Substantive response of the Local Highway Authority to a planning consultation received under The Development Management Order.

Planning Application Number: 25/01169/FUL

Application Address: Peggs Close Earl Shilton Leicestershire

Description of Application: Erection of 15 houses and 6 flats with associated parking and landscaping

Figure 1

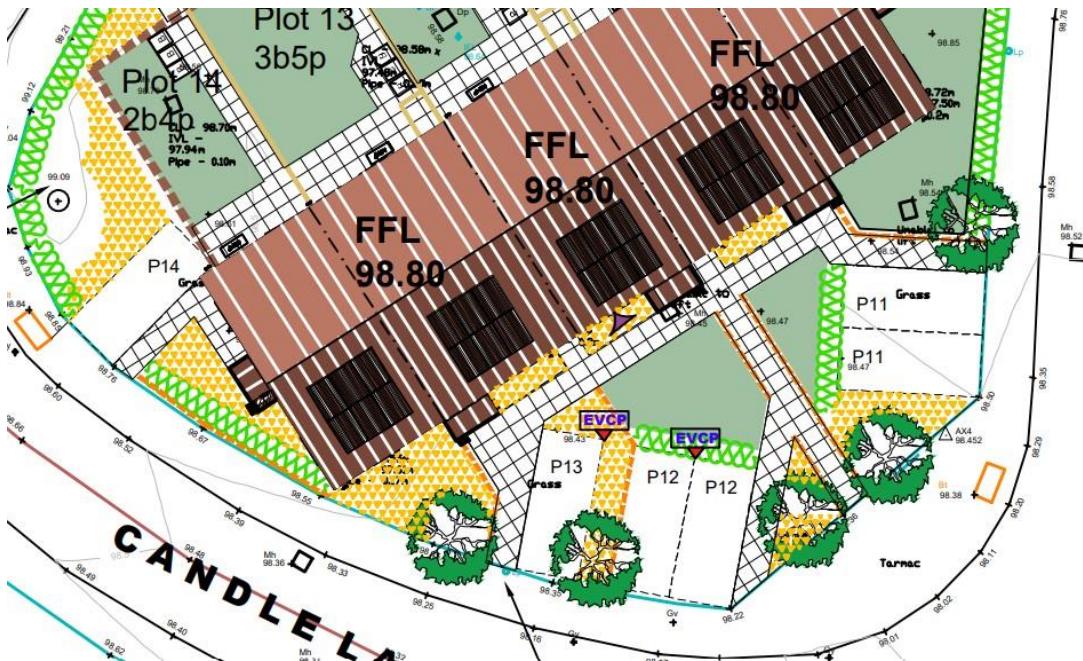
The LHA have concerns that the off-street parking for plots:

Plots 11 to 14 have not been demonstrated as being in accordance with the section of the LHDG titled [**'Private Access Restrictions'**](#) that states the following:

As such, the Applicant should re-consider these off-street parking locations.

For the avoidance of doubt please see Figure 1 below:

In terms of visibility splays, the LHA have concerns regarding parking for plots 12 and 13 as in Figure 1 above. Visibility splays to the northwest appear to be impeded by plot 14. The Applicant should provide visibility splay details via a detailed, scaled drawing in accordance with [Table 6](#) of LHDG. The Applicant should also note there should be nothing above 0.6m within these splays, this includes planting.

[**Table 3**](#) of the LHDG states that developments should be set back a minimum of 0.5m from the public highway. The LHA have scaled from the drawing titled 'Proposed Site Plan', drawing number 2724 / P 102 Rev B and finds that the corner of plot 14 to be closer than this. This can be seen within Figure 1 above.
